Submittal Cover Sheet

Submittal Title:	<u>Traffic Control Plan & Temporary Pedestrian</u> <u>Access Route</u>
Project Name:	Williston STP 5500 (17)
Date:	March 24, 2025
ECI Submittal Reference Number:	240265-08-Rev02
Manufacturer / Supplier / Subcontractor:	N/A
Specification / Drawing References:	641.02
Submittal Prepared By:	Nathan Lougee
	eviation from the Contract Documents.
The undersigned attests that the undersigned h requirements of the Contract Documents have	nas carefully examined this entire submission, and the been met.

TRAFFIC CONTROL PLAN (TCP) & TEMPORARY PEDESTRIAN ACCESS ROUTE(TPAR)

Williston STP 5500 (17)
Williston, VT
Prepared for

On-Site Contact: PHASE 2A 0 50 100150200ft Site Induction: Date Drawn: Scale 1:3025 License #: Drawn By: NRL Posted Speed: Reduced Speed: Revision: Signature: **Date and Time of Project:** Start: 4/14/2025 - End: 10/16/2026 02

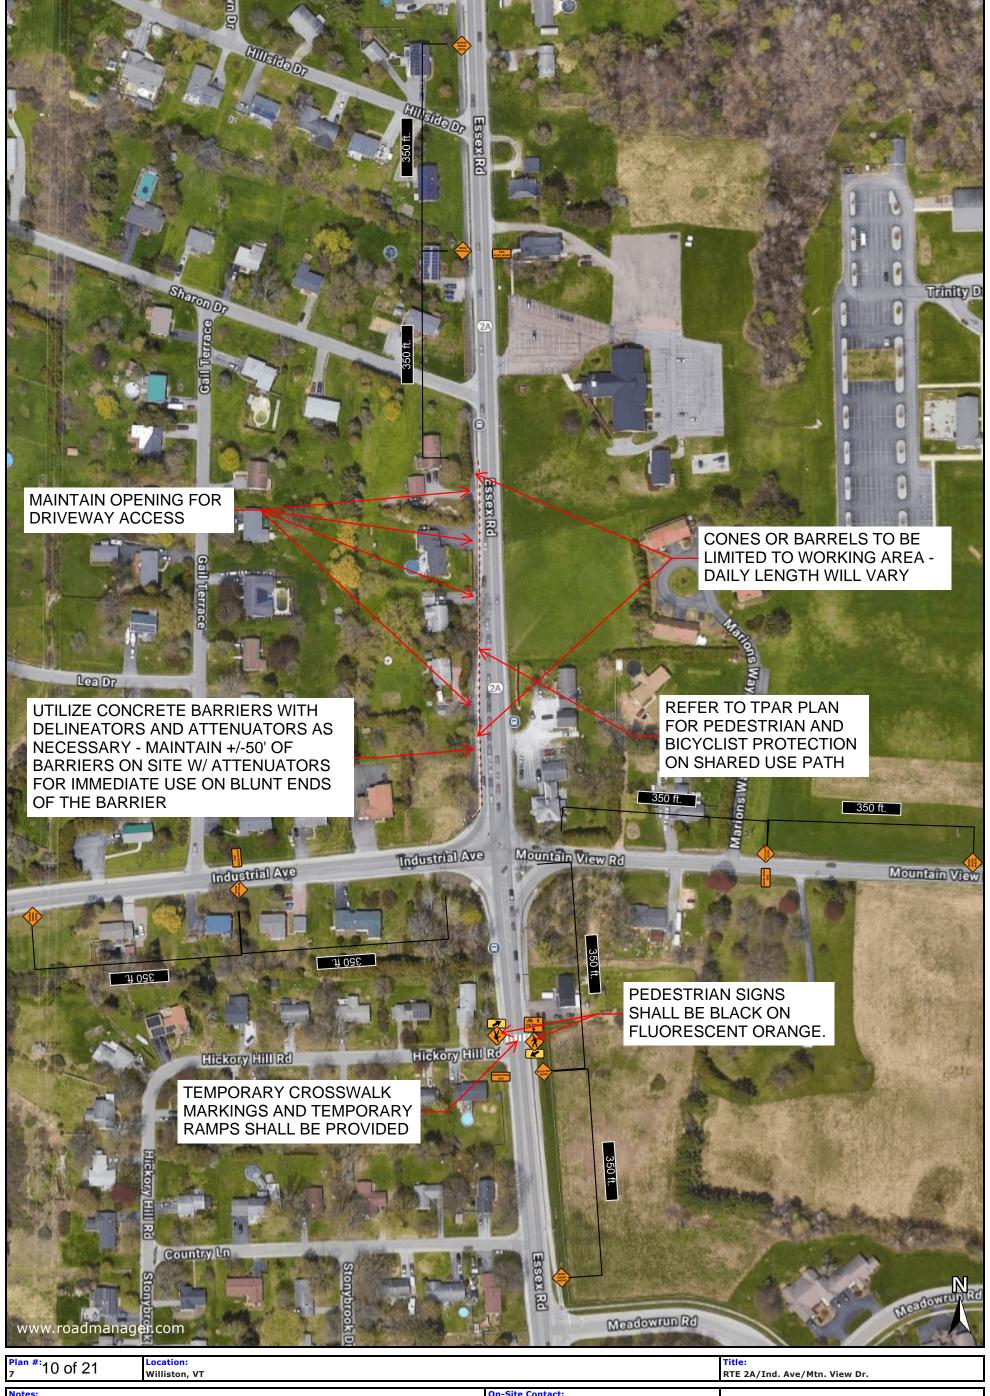
Τ	<u> </u>	T
	(4) - It should be noted that the barrier itself shall		
	not be placed along the merging taper. The lane		
	shall first be closed using channelizing devices		
	and pavement markings. Please refer to TA-5 for		
	a similar set-up for a shoulder closure and TA -34		
	for a freeway lane closure. There is no good		
	example in the MUTCD for conventional		
	roadways with the use of concrete barriers.		
	Reference TA-12 for the signalized lane closure		
	on a two-lane road then add your concrete		
	barrier behind the channelizing devices with the		
	correct flare rate. (See 11th edition MUTCD		
	Section 6M.02 Positive Protection and		
18	Temporary Traffic Barrier paragraph 07-09).	Plan 9 of 21	Noted

TPAR - PHASE 1A

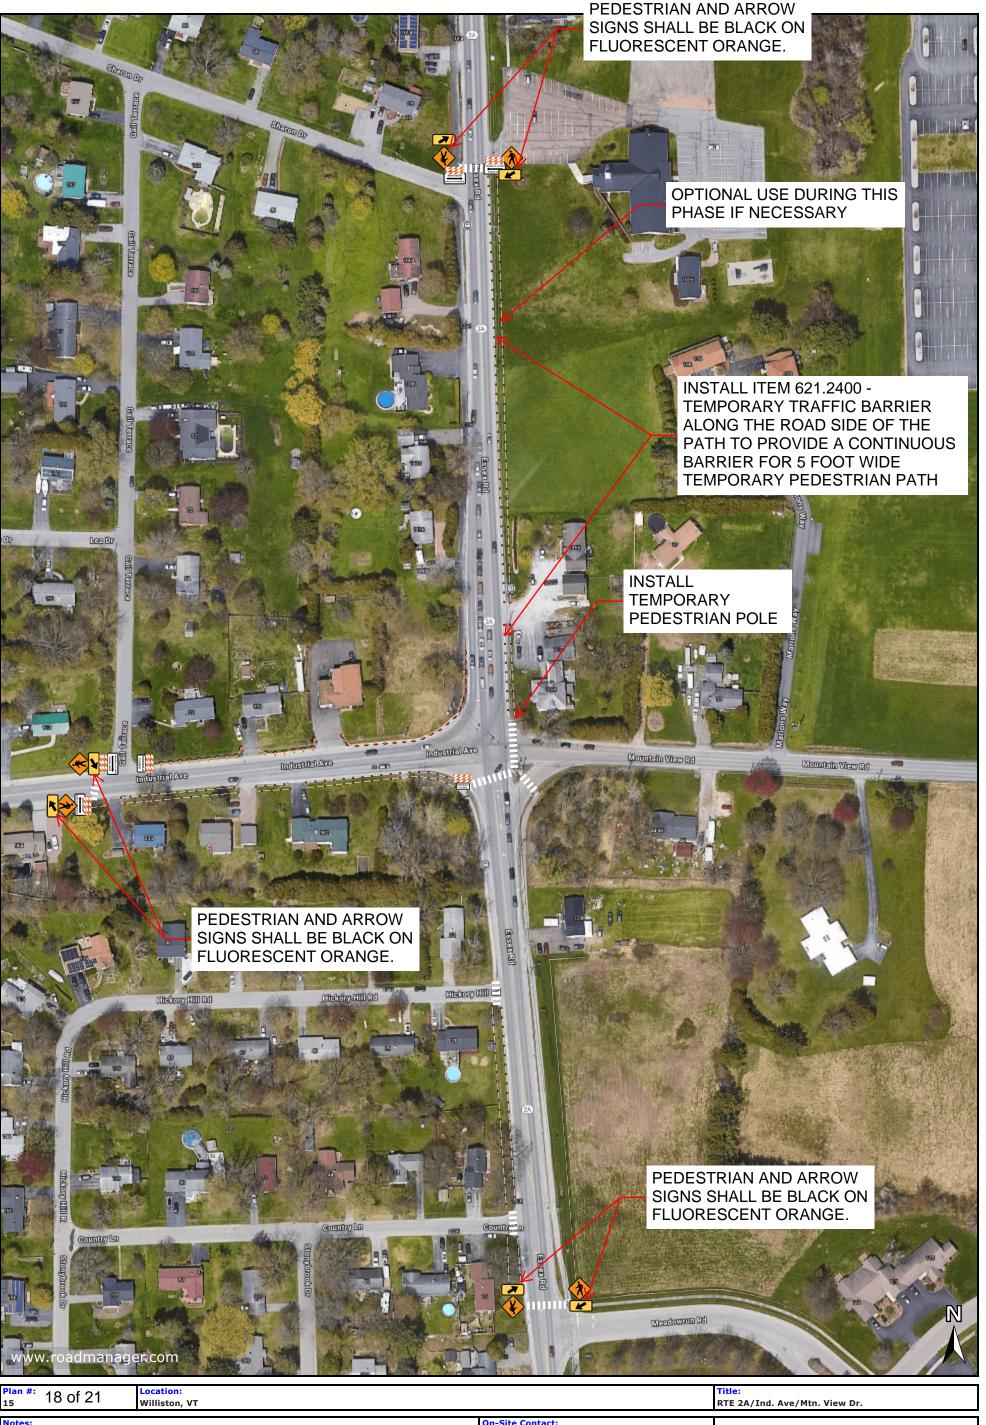
(O) Typical nata		
	(9) - Typical note -		
	Individual channelizing devices, tape, or rope		
	used to connect individual devices and other		
	discontinuous barriers and devices, pavement		
	markings are not detectable by persons with		
	visual disabilities and are incapable of providing		
	detectable path guidance on temporary or		
	realigned sidewalks or other pedestrian facilities.		
	(11th edition MUTCD 6M.04, paragraph 1) When		
	it is determined that a facility should be		Noted - ECI will install Item
	accessible to and detectable by pedestrians with		621.2400 - TEMPORARY
	visual disabilities, a continuously detectable		TRAFFIC BARRIER along the
	edging shall be provided throughout the length		road side of the path to
	of the facility such that it can be followed by	Plan 10-13, 15-	provide a continuous
20	pedestrians using long canes for guidance.	19 of 21	barrier.
			•

(2) - Sidewalk closed sign to be installed on		Type 3 Barricades added to
	modified Type 3 Barricades that meets ADA		block pedestrians - Please
	requirements to block from pedestrian entrance.		note pedestrians may use
	Regulatory and warning signs can not be installed		Sharon Drive and Gail
21	on the same assembly	Plan 17-19 of 21	Terrace.
	This location does not allow for allowable sight		
	distance for the speed on this roadway. This		ECI moved sign to
	suggest area is not conducive for a ped crossing		Meadowrun Road at <u>+</u> STA
22	do to the crest of the hill.	Plan 17-19 of 21	245+25
	Sidewalk Closed		
	<		
23	Cross Here	Plan 20 of 21	Changed sign
